HISTORIC AND DESIGN REVIEW COMMISSION

March 20, 2019

HDRC CASE NO: 2019-084
ADDRESS: 914 N PINE ST
LEGAL DESCRIPTION: NCB 1653 BLK A LOT 5
ZONING: R-5, H
CITY COUNCIL DIST.: 2
DISTRICT: Dignowity Hill Historic District
APPLICANT: David Ericsson
OWNER: Pine 14, LLC
TYPE OF WORK: Construction of carport
APPLICATION RECEIVED: February 15, 2019
60-DAY REVIEW: April 16, 2019
REQUEST:

1 CARPORT

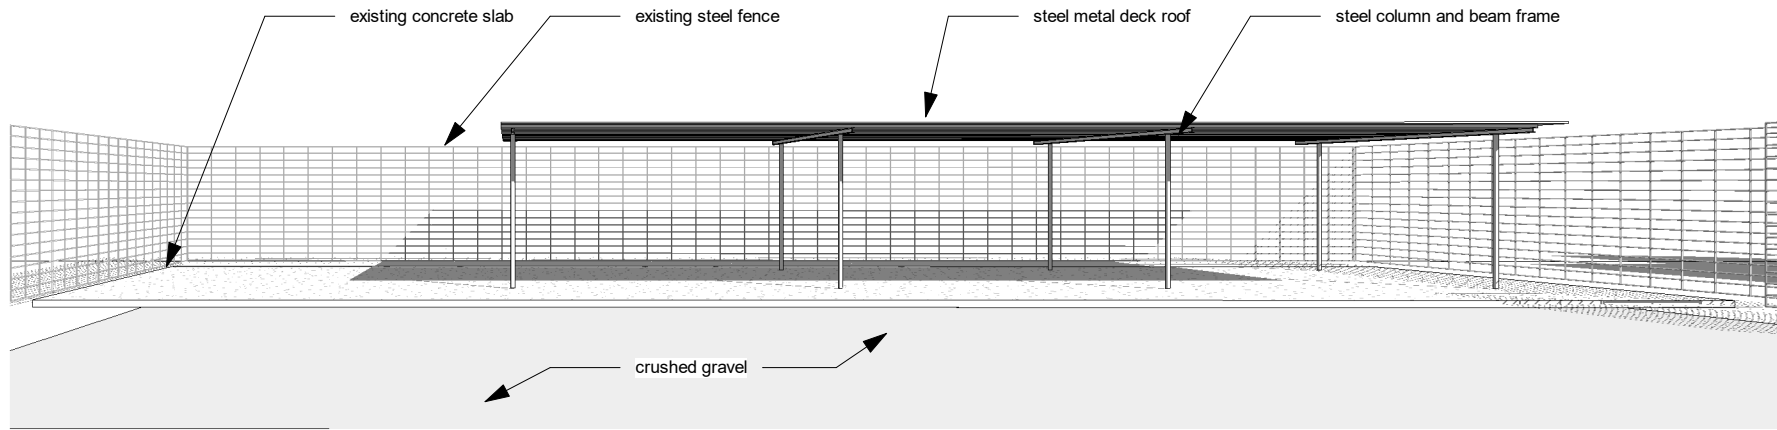
- b. CARPORTS – The Guidelines for New Construction 5.A. notes that new garages and outbuildings are to be visually subordinate to the primary structure in regards to form, massing and height; should relate to the period of construction of the primary structure through complementary materials and simplified architectural details. As noted in finding a, the applicant has proposed a steel carport structure. The proposed carport structure will feature

steel columns and beams and steel metal roof decking. Regarding size, the proposed carport will feature an overall depth of 18' – 11" and an overall length of approximately 52'. Materials used on the new construction of the primary residential structures as well as both primary and accessory found historically throughout the district feature non-metal materials. Staff finds that framing materials consisting of wood would be consistent with the Guidelines.

- i. That the proposed carport be constructed of wood materials rather than the proposed steel.

2 SITEPLAN 914 CARPORT

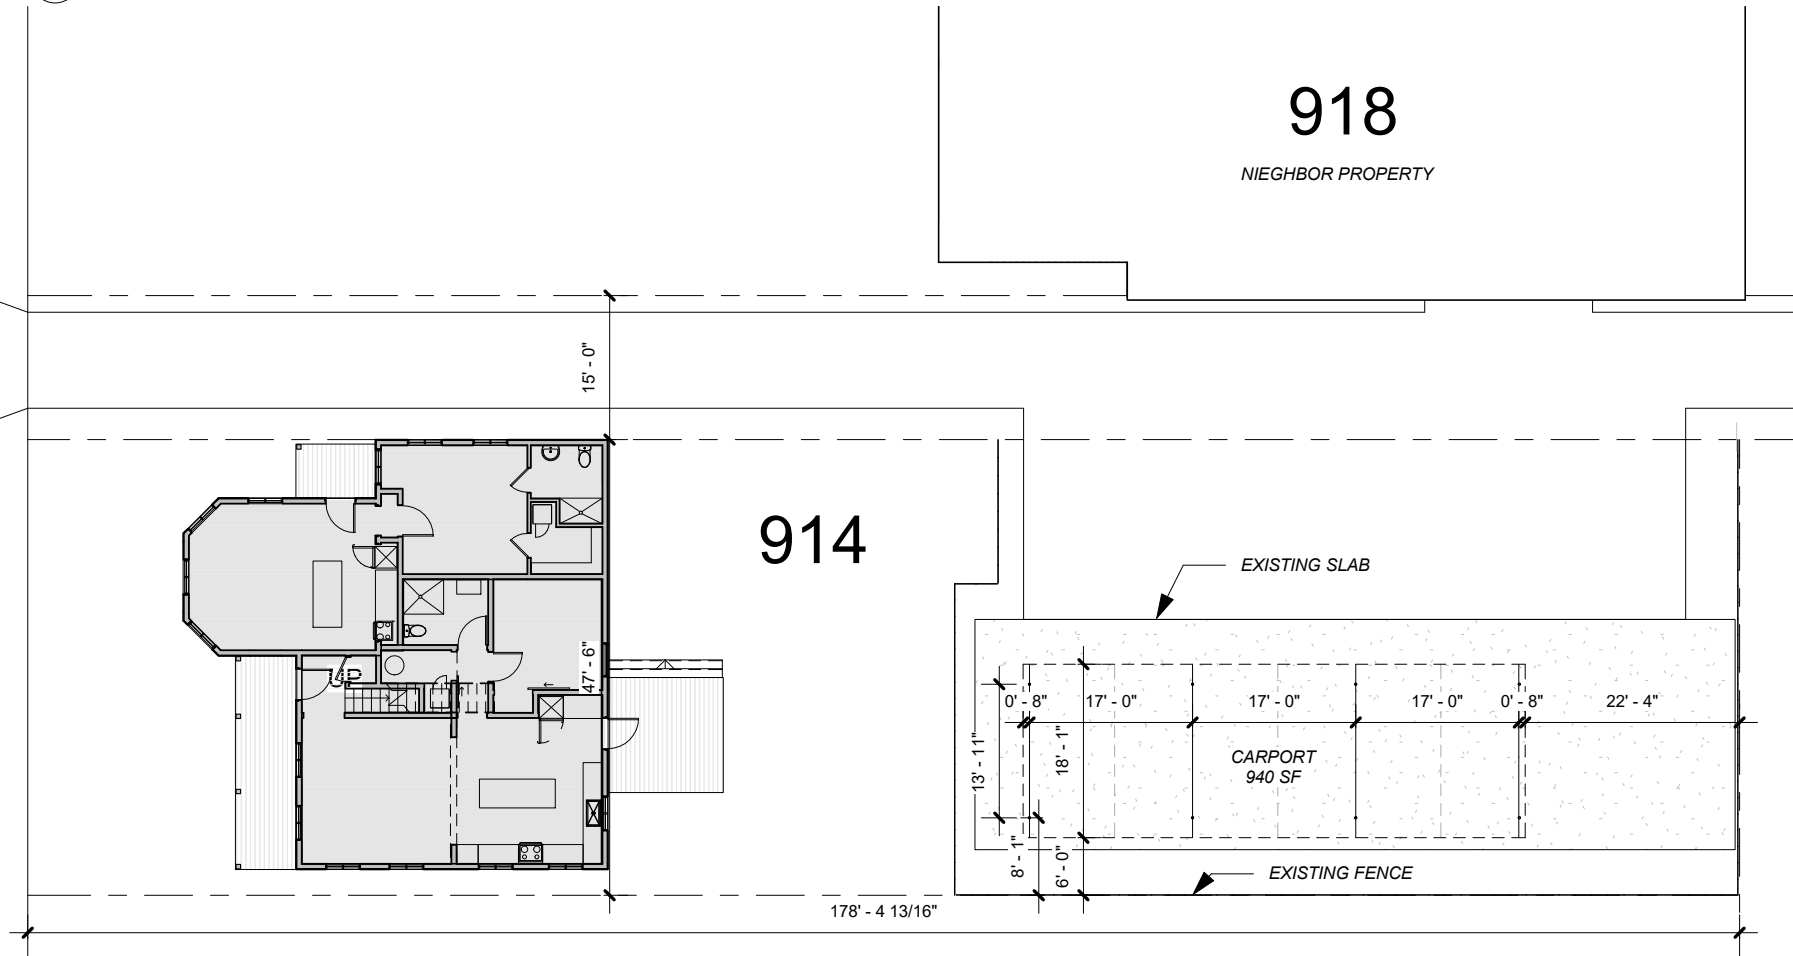
- c. SETBACKS & ORIENTATION – The Guidelines for New Construction 5.B. notes that new accessory structures should match the orientations of those found along the block and should follow the historic setback pattern of similar structures found along the streetscape or district for new accessory structures. Generally, staff finds the proposed location to be appropriate.
